PCI-SIG ENGINEERING CHANGE NOTICE

TITLE:	PCI Express Base PCI Bus Power Management Spec Updates
DATE:	January 7, 2005
AFFECTED DOCUMENT:	PCI Express Base Specification 1.0a
SPONSOR:	Ken Stufflebeam : Microsoft Corporation

This ECR updates the PCI Express Base Specification to come into line with revision 1.2 of the PCI Bus Power Management Specification.

Figure 7-16: Power Management Status/Control Register

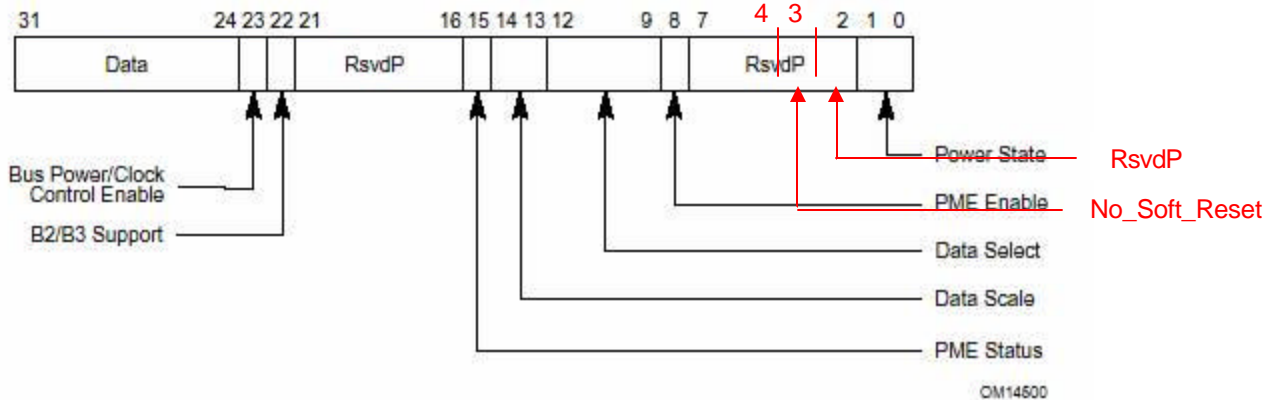
Figure 7-16 – corrected fields to reflect PCI Express reserved and No_Soft_Reset bits

Current Power Management Status/Control register does not show the new bits defined with revision 1.2. Since figure is included, it should be updated to reflect current configuration.

Add "No_Soft_Reset" and "Reserved for PCI Express" bits in Figure 7-16: Power Mangement Status/Control Register:
